**Re: Allaso Vineyards Apartments PHASE 1-3/ 8901 Holly Ave. NE**  
**Request for Certificate of Occupancy**  
**Transportation Development Final Inspection**  
Architect's Stamp dated 09-01-21 (C20-D086)  
Certification dated 09-24-24

TRAFFIC CERTIFICATION FOR ALLASO VINEYARDS PHASE 1-3  
BP-2021-38293

A1 SITE PLAN - OVERALL  
1" = 20'-0"

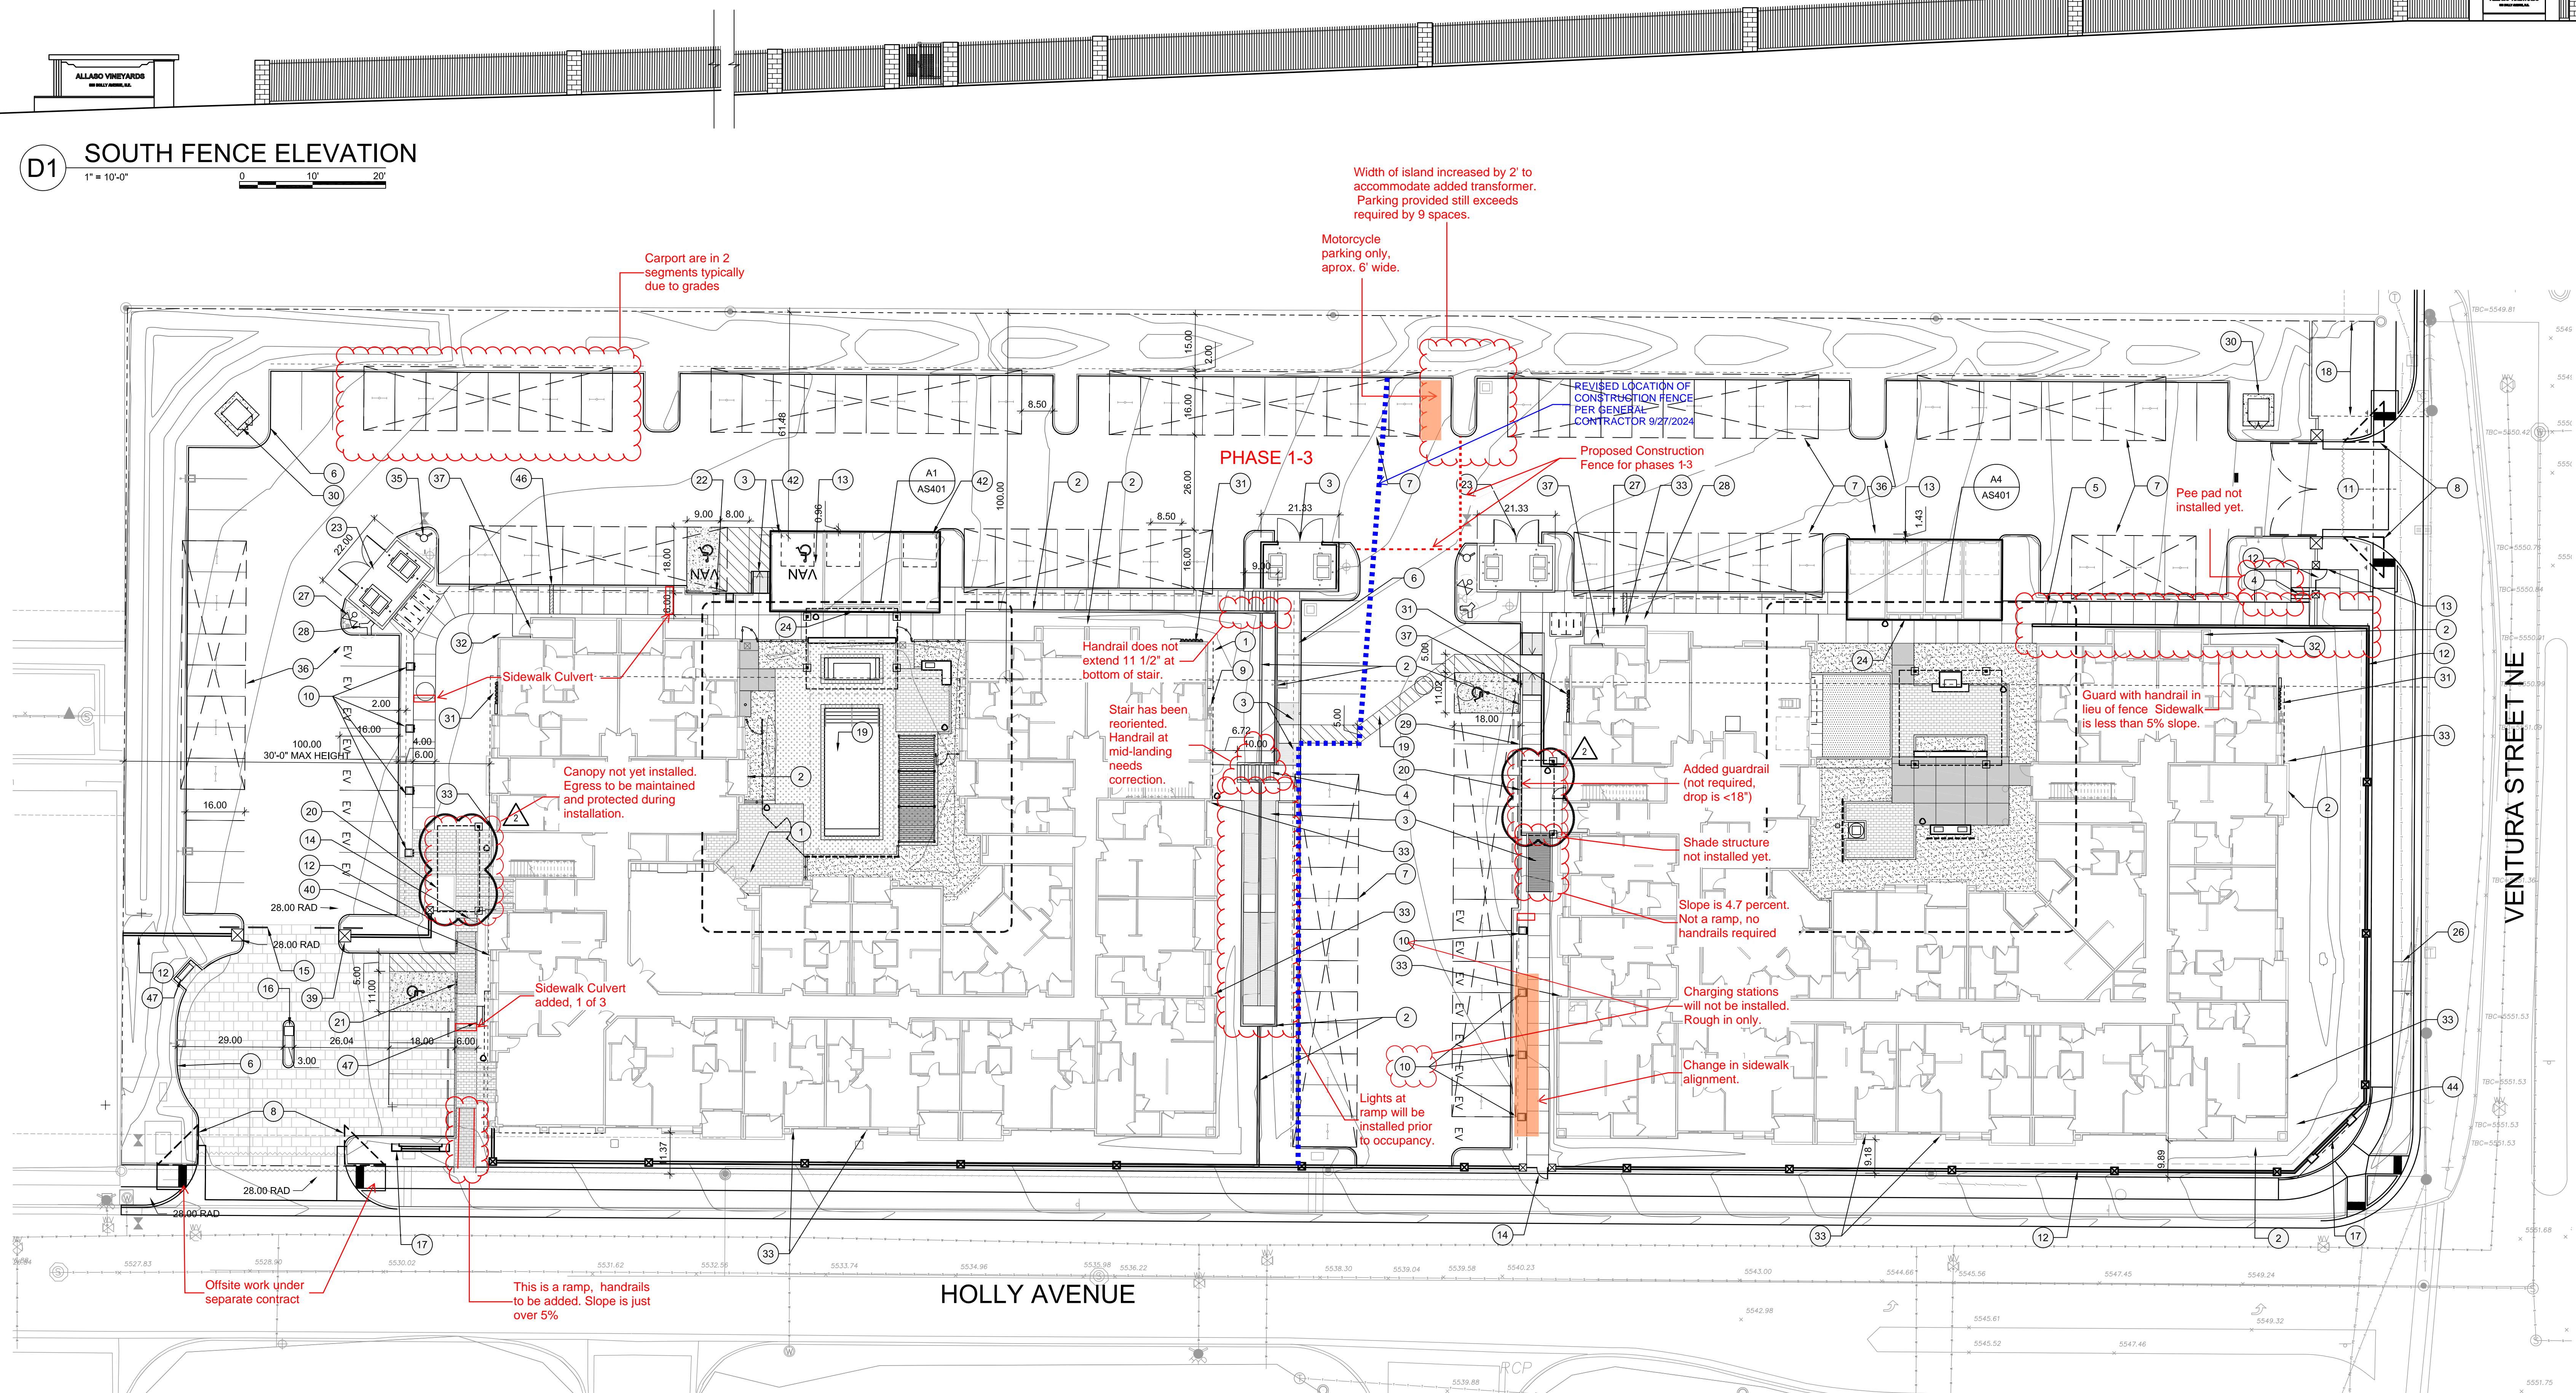
1. *Handrails to be added at ramp at SW corner of Building 1.*
2. *Canopy at West end of Building 1 is not yet installed.*
3. *Handrail extension needs to be corrected at NE corner of Building 1.*
4. *Railing extensions to be cut back East of Building 1.*
5. *Lights to be installed prior to occupancy at site ramp East of Building 1.*
6. *Construction fence for Phases 1-3 is not yet installed. Emergency egress from west stairwell of Building 1 to be maintained at all times. General contractor will be responsible for maintaining this egress path.*
